Indirect Measurement Summary

Brier Creek near Langley, Arkansas

Flood of June 11, 2010

Type of measurement: Slope Area

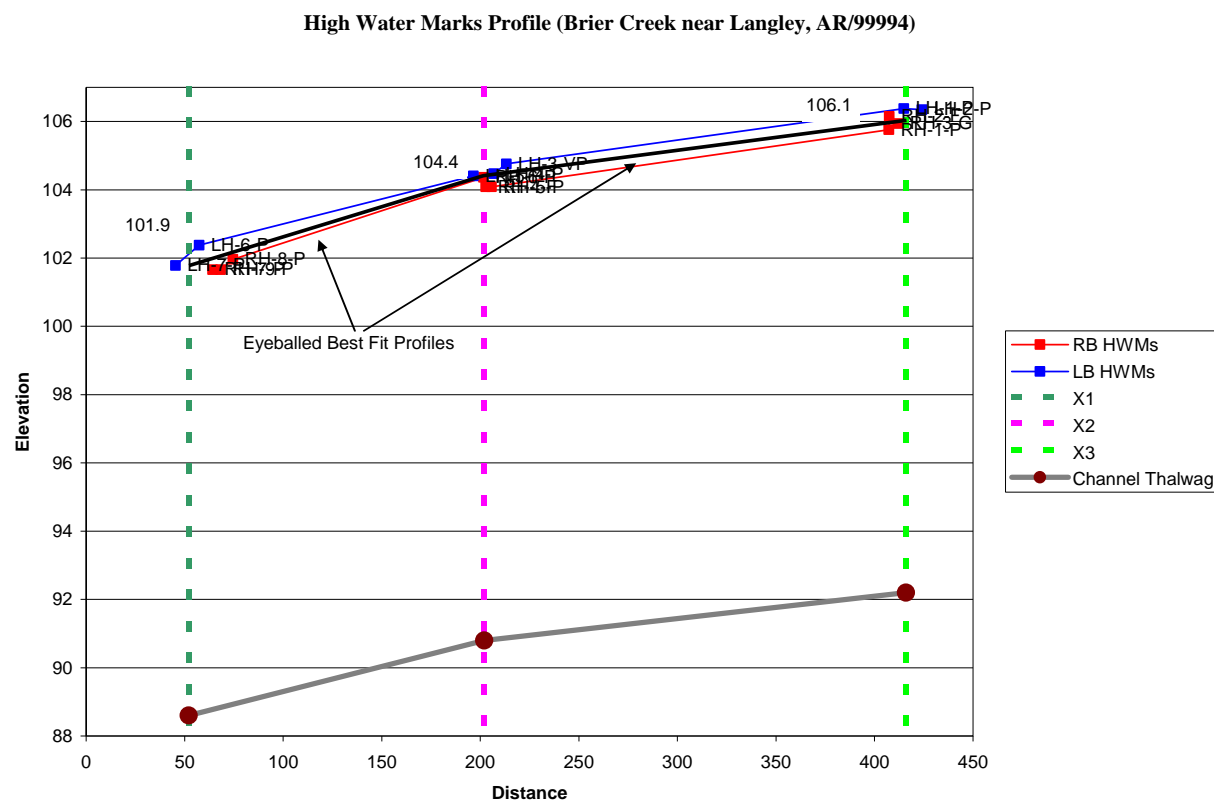
1. The photographs taken at the cross sections indicate the main channel is noticeably rougher from upstream to downstream (XS3 to XS1). However, the n-values for the main channel was lowered from cross section 2 to 1 (.065 to .061).
I do not see the same “noticeably rougher” going from upstream to downstream in XS2 to XS1. A review of the video (P6170040.mov and P6170041.mov) shows approximately similar sized bed material (boulders) in both XS 2 and XS1, but denser vegetation XS2 as opposed to XS1. Thus XS2 was given a main channel n = 0.065 with XS1 n = 0.061. XS3.

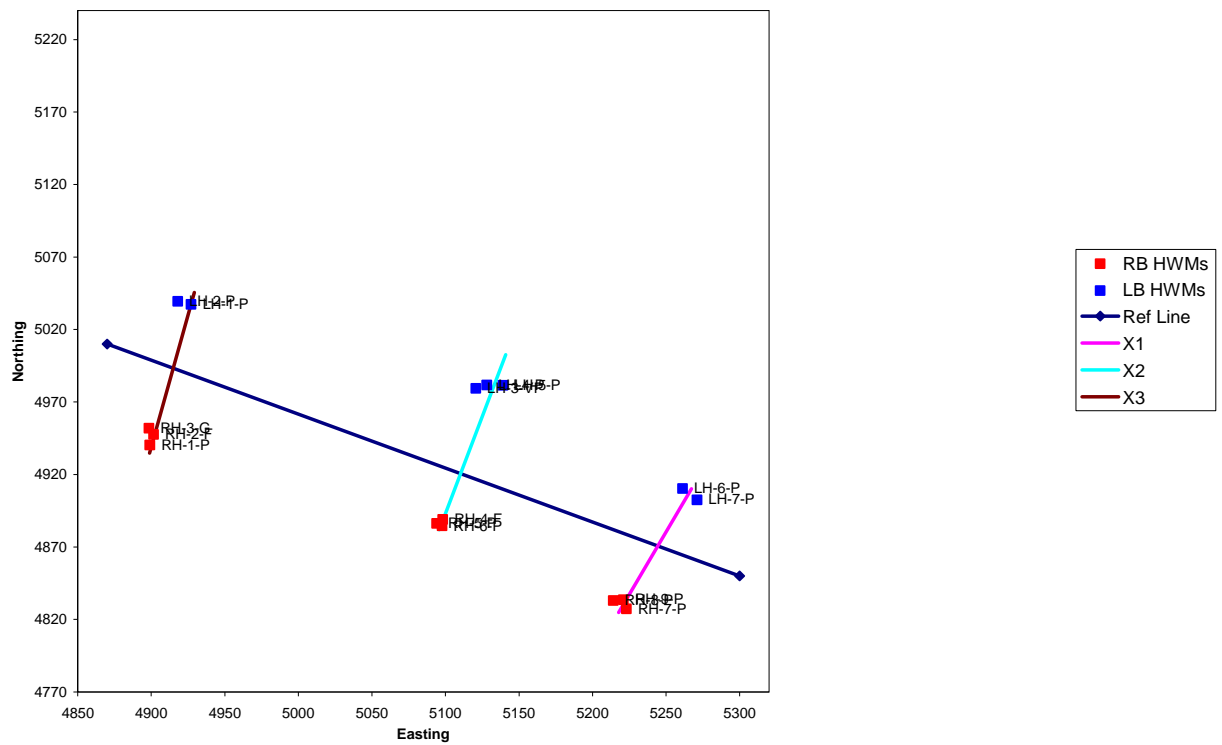
3. Were high-water profiles on the banks established for the indirect? High-water marks were only plotted at the immediate ends of the cross sections. It is best to establish high-water marks a considerable distance above and below the reach of interest according to the TWRI's (Book 3, Chapter A1). The high-water marks at cross section 1 appear to be low compared to upstream marks and thalweg elevations. Suggest using a water-surface elevation of 102.0 ft or 102.1 ft instead of 101.7 ft for cross section 1.

No high water marks other than what are plotted in the profile plot are available. I will raise the downstream the water surface elevation at XS1 to 101.9 to better reflect the average of the left bank and right bank high water marks at that section. With this change, slope area computation lowers the peak streamflow from 6550 ft³/s to 6,530 ft³/s, a change of -0.3 %.

Below I have plotted the channel thalweg profile which shows an increase in channel slope downstream of XS2 as opposed to upstream. This increase in slope is reflected in the water surface profile
